Proposed N24 Beary's Cross Road Improvement Scheme

N24 Beary's Cross Road Improvement Scheme

ROAD DESIGN - PART 8 REPORT

Report No. 15033-P8-Rsp

RE: N24 Beary's Cross Road Improvement Scheme - Part 8 Development

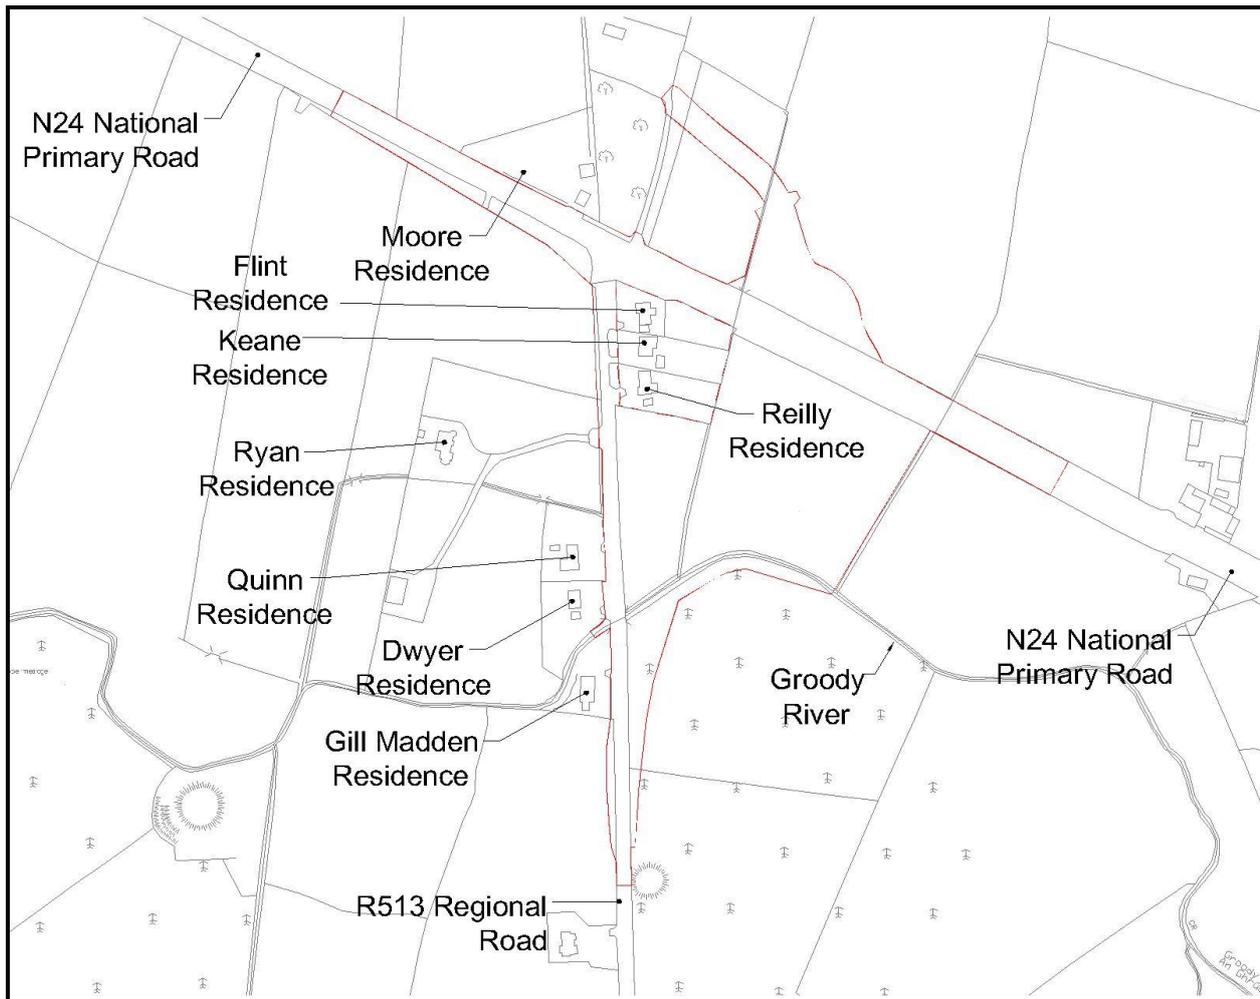
- (i) Replace the existing access from the Moore Residence to the proposed GAA access road;
- (ii) Provide a right-turn lane at the access to the Gill Madden Residence and ensure access is suitable for traffic turning left off Regional Road;
- (iii) Increase the width of and provide pedestrian facilities on the cul-de-sac;
- (iv) Provide signalised Pedestrian crossings on the N24;
- (v) Provide traffic calming, pedestrian and cyclist facilities between Beary's Cross and Boher;
- (vi) Impose a 60 km/h speed limit over the extent of the Scheme.

- (vii) Provide banked verges on the N24 or other measures to deter illegal parking;
- (viii) What is the proposed use for the green area opposite Quinn / O'Dwyer Households

- (ix) Access between O'Dwyer and Gill Madden residences to be maintained;
- (x) Open green areas to be landscaped.
- (xi) Provide landscaping and fencing across existing R513 at its junction with the N24;
- (xii) Provide boundary walls and fences at a number of locations.

- (xiii) Limerick City & County Council to commit to address any flood-risk issues not anticipated by the Part 8 report;
- (xiv) The height of the realigned R513 not to be raised above the height of the existing road;
- (xv) Provide a new wastewater treatment system to mitigate the impact of the Scheme on existing systems;
- (xvi) Provide measures to relieve the risk of flooding and its ancillary effects.

- (xvii) Provide measures to enhance safety and security on the cul-de-sac, including lighting and surveillance cameras;

- (xviii) Provide information signs for existing businesses and a community alert scheme and provide signs prohibiting illegal parking, temporary dwellings and overtaking on the realigned R513.

- (x) Landscaping will be provided in accordance with TII landscape guidance documents. The exact treatment will be the subject of the detail design.
- (xi) The submission requests the erection of walls and fences and planting of hedges at a number of locations (hedges to be planted adjacent to new boundary fences, boundary walls on the R513, erection of a new fence at the O'Dwyer property, walls to the side of the Reilly property and to the rear of the O'Meara's property). In general it is proposed that fencing will be erected to separate the public land from the private land and to separate the N24 National Road from the cul-de-sac. This will be supported by the landscaping design to enable the revised road layout arrangements to merge into the landscape.

Traffic signage on the National Road will be in accordance with TII guidance. Where non statutory signage is in question such as 'community alert' signs these are subject to a separate planning process distinct from this scheme. Where the signs are a matter for the Council itself such as 'no parking' these may be provided in line with the Council's own procedures for these matters.

The location of the Quinn Property is shown on Figure 1-1.

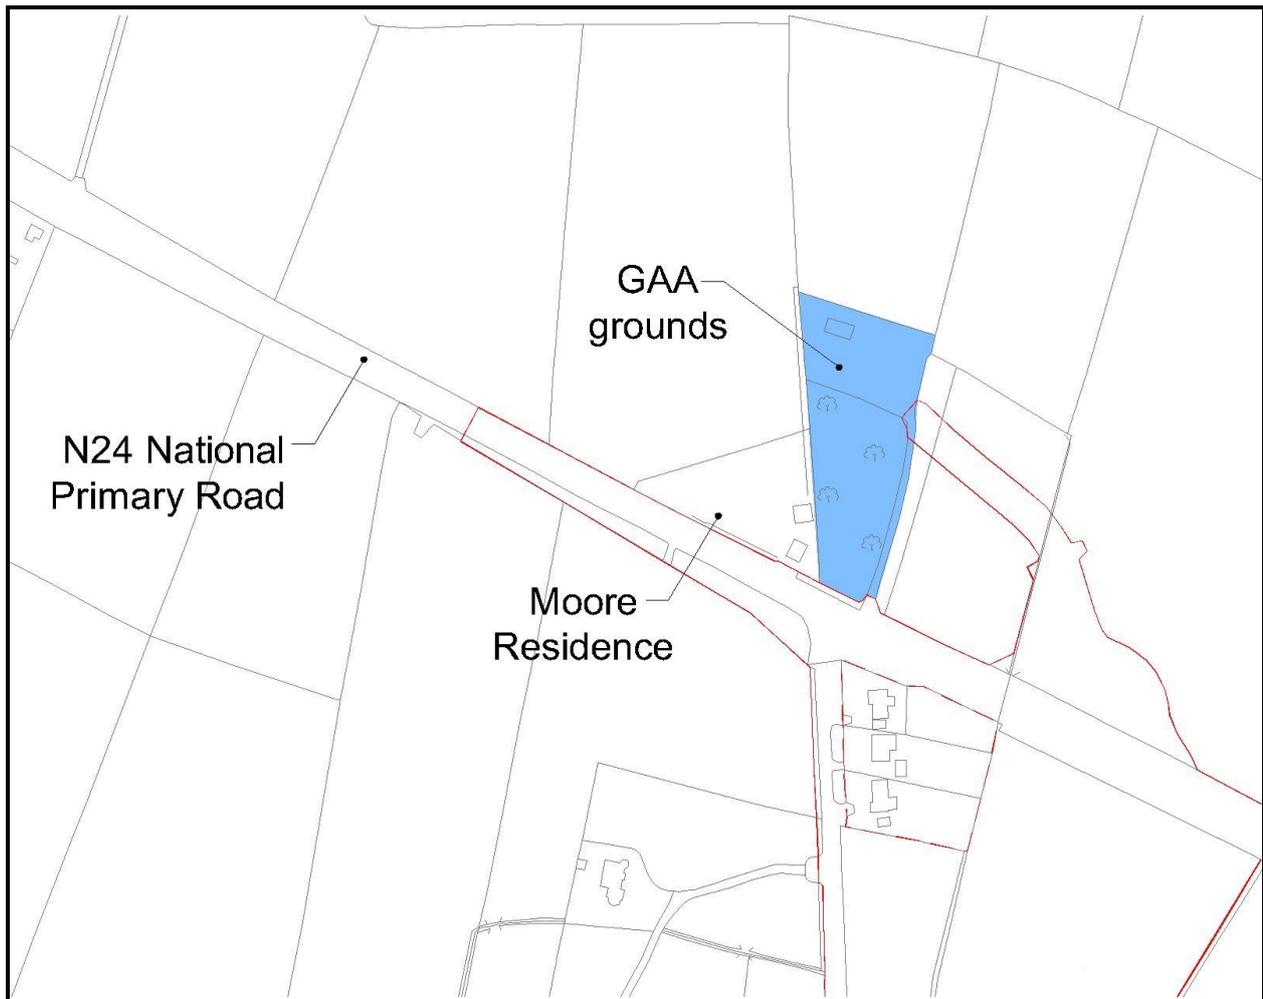
This submission is the same as Submission 1, except for a statement that the Quinn household would be willing to consider an offer for the purchase of their home should Limerick City and County Council wish to do so in order to carry out their planned works. This statement arises from a concern that the flood risk outlines in the plans will negatively impact on the value of the Quinn property.

The response to Submission 1 can be taken as the response to all other items in this submission.
